From: Michael Bingham [mailto:MBingham@apexcos.com]
Sent: Monday, August 12, 2013 11:06 AM
To: Tisa, Kimberly
Cc: Chet Myers; Gregory Dolan
Subject: RE: Revised Sampling Plan - Geotechnically unsuitable material

**SAMPLING AND ANALYSIS PLAN
FOR
“Geotechnically Unsuitable Soils”**

Massachusetts Clean Energy Center

**New Bedford, Massachusetts
August 12, 2013**

Examples of stockpile sampling grids

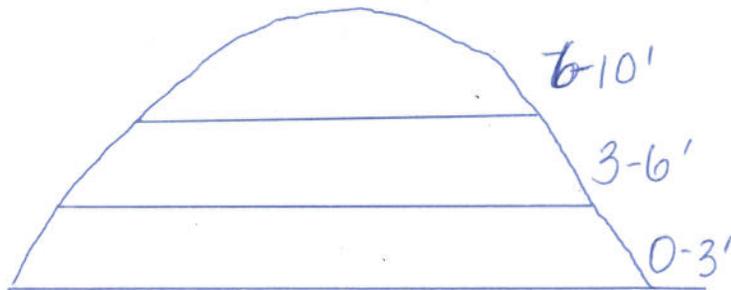
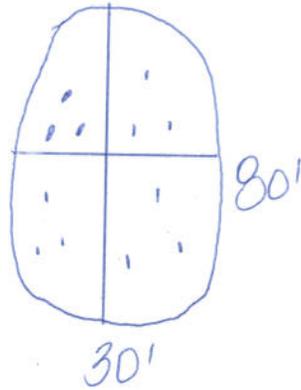
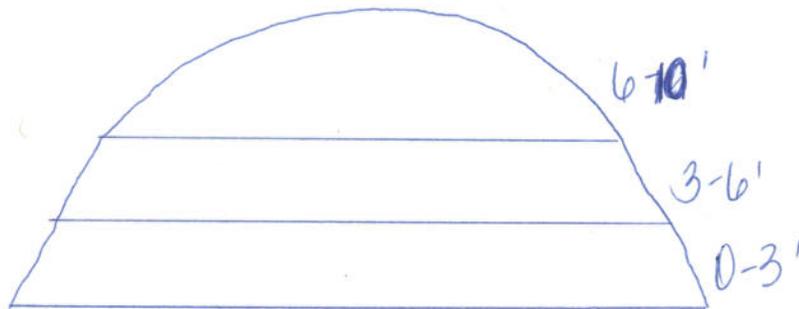
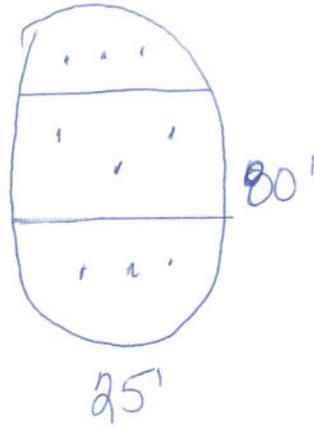
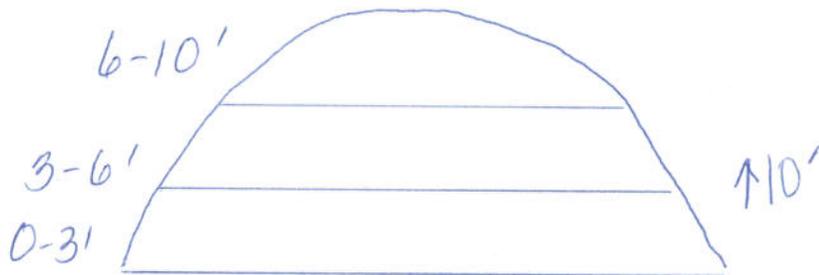
Conceptually, the stockpile SAP currently being discussed would appear to be sufficient to determine whether a stockpile is < 50 ppm or > 50 ppm for off-site disposal purposes. However, as I discussed with Mike today, I believe that a more systematic approach to grid sampling of piles is more defensible than just using a volume estimate. Attached are examples of a sampling protocols for several different stockpiles varying in both size and dimension. The approximate # cubic yards per sample shown in these examples is smaller than 1 sample per 100 cubic yards, so I am willing to discuss once you have an opportunity to review. (Please no comments on my artistic ability.....)

At this point I would recommend developing the plan for off-site disposal incorporating the suggested sampling protocols that is attached, and see what the data results are. We can discuss the final sampling protocol once you have an opportunity to review the examples I've provided.
